ADDENDUM NO. 1

December 2, 2021

Cadillac High School Addition & Renovations

This Addendum forms a part of and modifies the Bidding Requirements, Contract Forms, Contract Conditions, the Specifications, and the Drawings dated November 3, 2021, by TowerPinkster. Acknowledge receipt of the Addendum in the space provided on the Bid Form. Failure to do so may subject the Bidder to disqualification.

3 P 301.2 FIRST FLOOR TOILET ROOM AREA ENLARGED PLUMBING PLAN - UNIT H

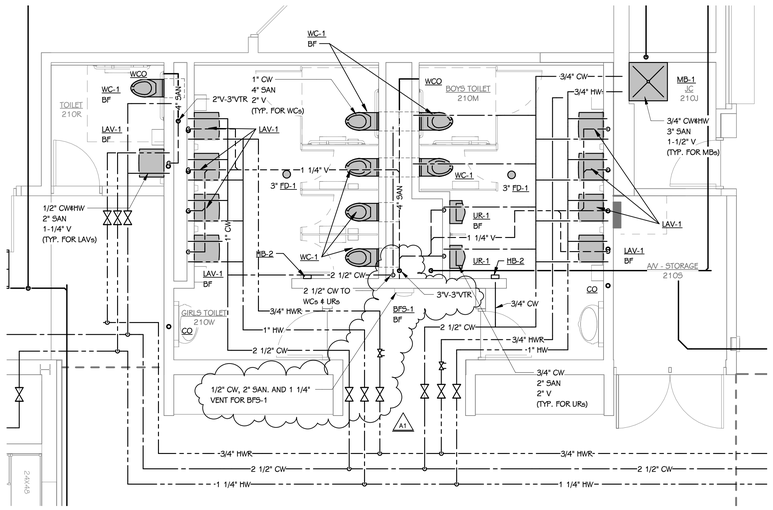
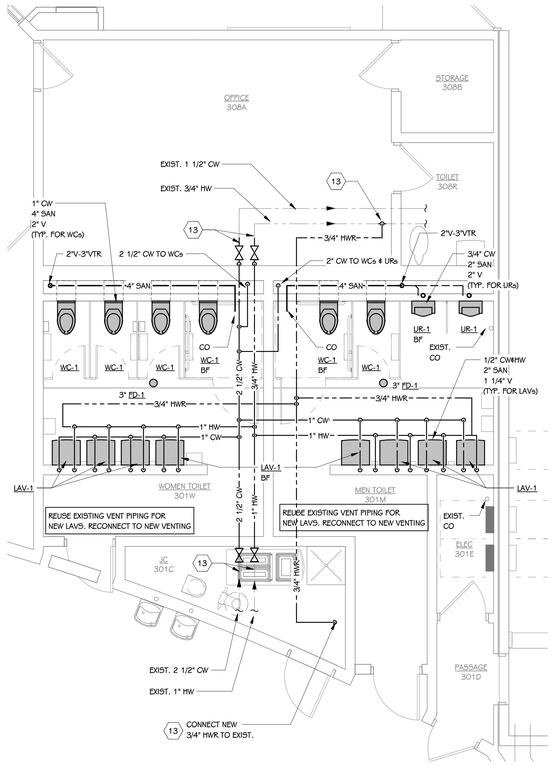
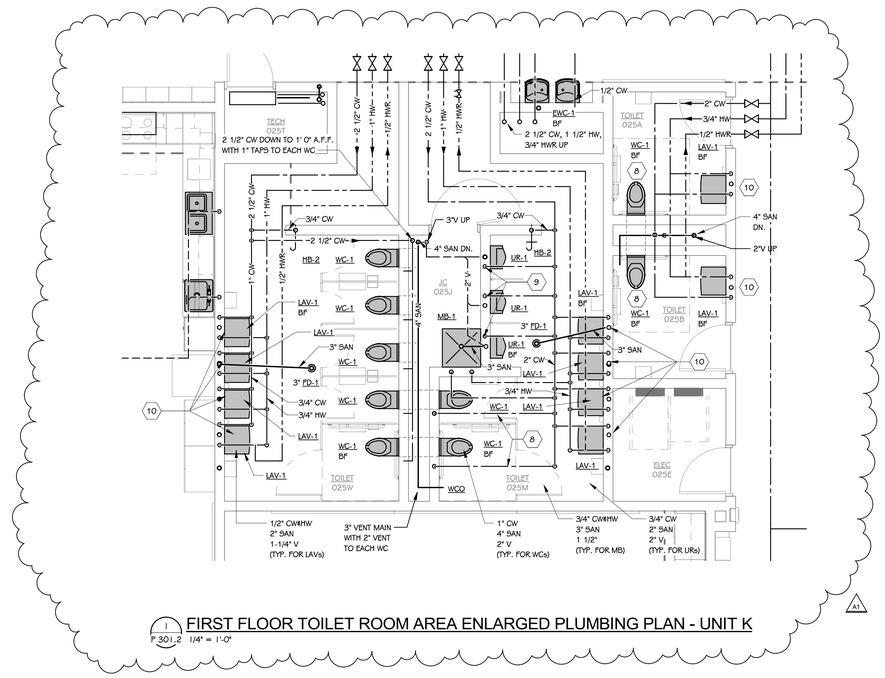
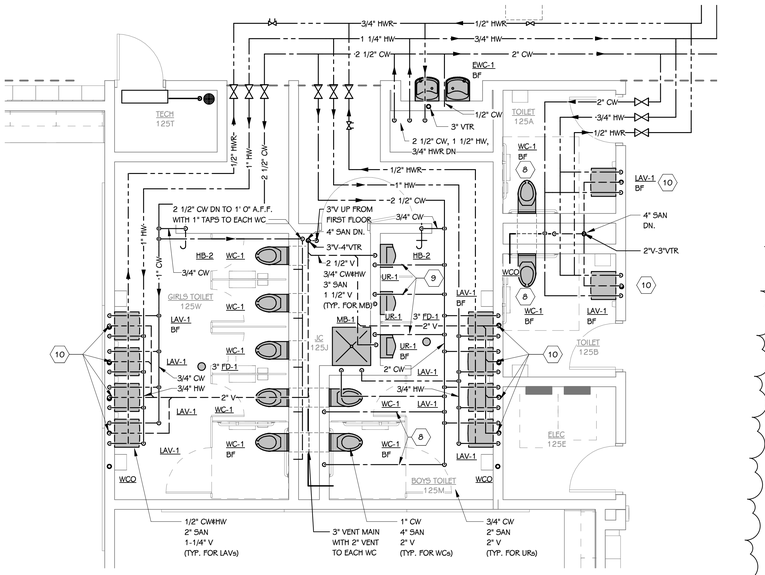
Refer to Sheet: P 301.2
